March 22, 1994
ML-94-008

Docket No. 70-36
License No. SNM-33

Subject: **Organizational Amendment**

COMBUSTION ENGINEERING, INC.
HEMATITE NUCLEAR FUEL MANUFACTURING FACILITY
ORGANIZATION AMENDMENT
EXPLANATION OF CHANGES

Figure II.3-1

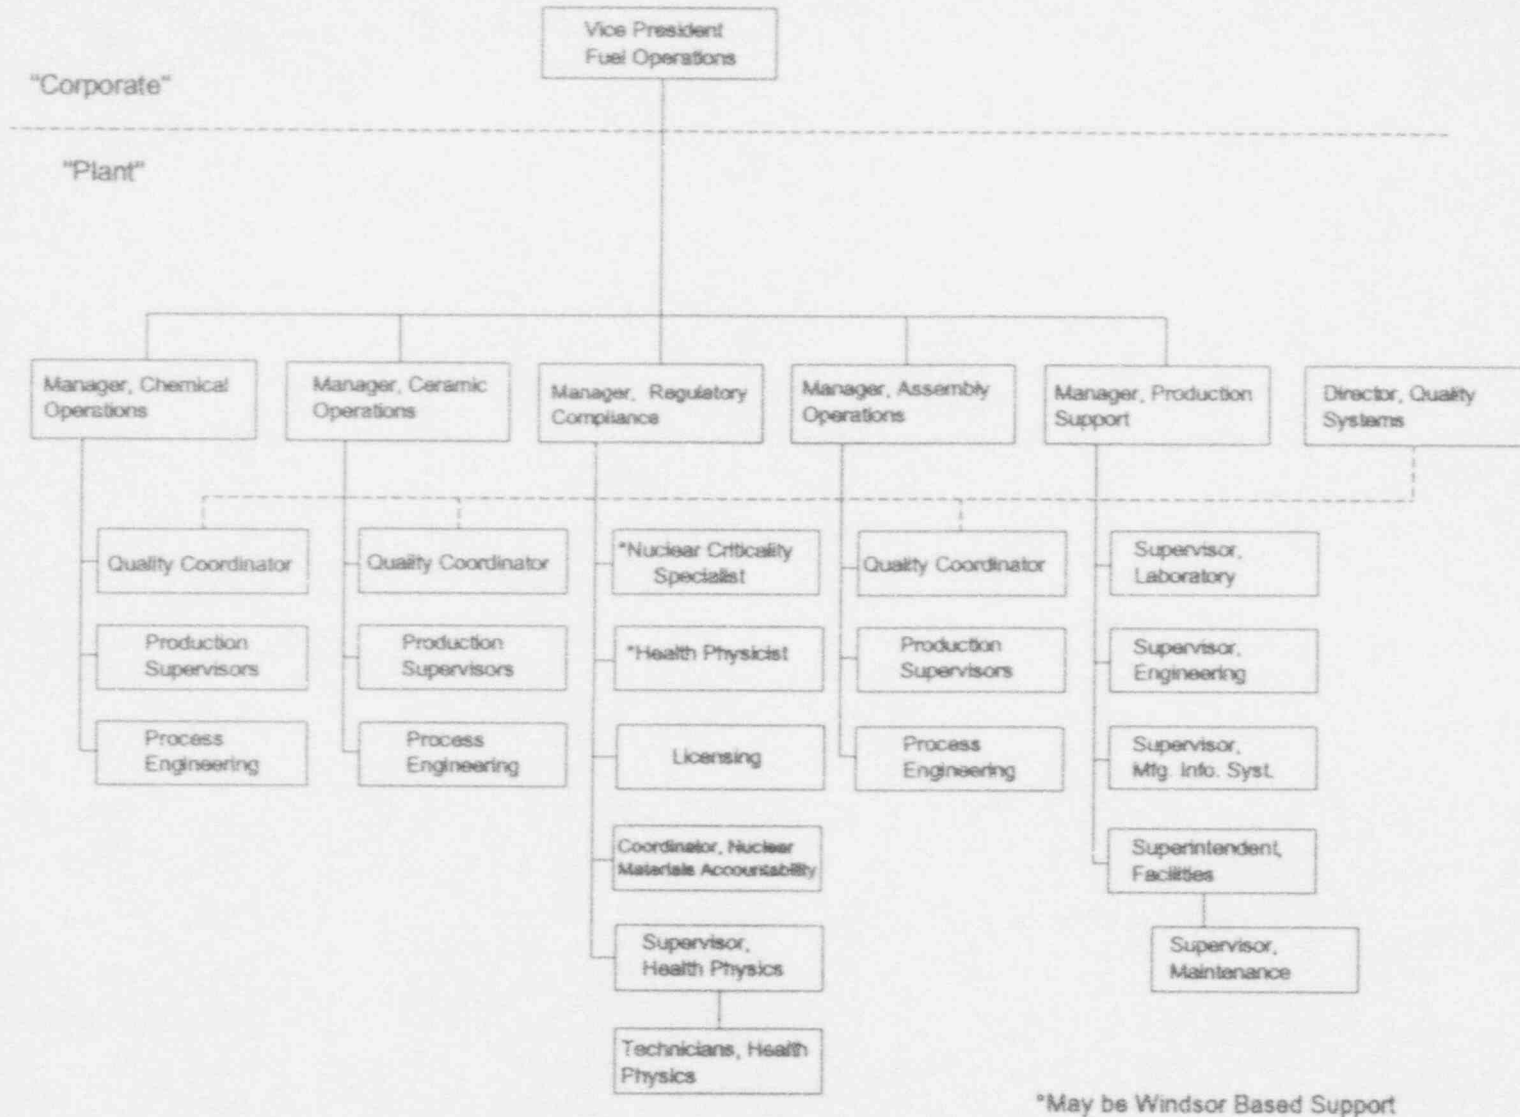
Lastly, the organization chart of Figure II.3-1 has been revised as previously discussed.
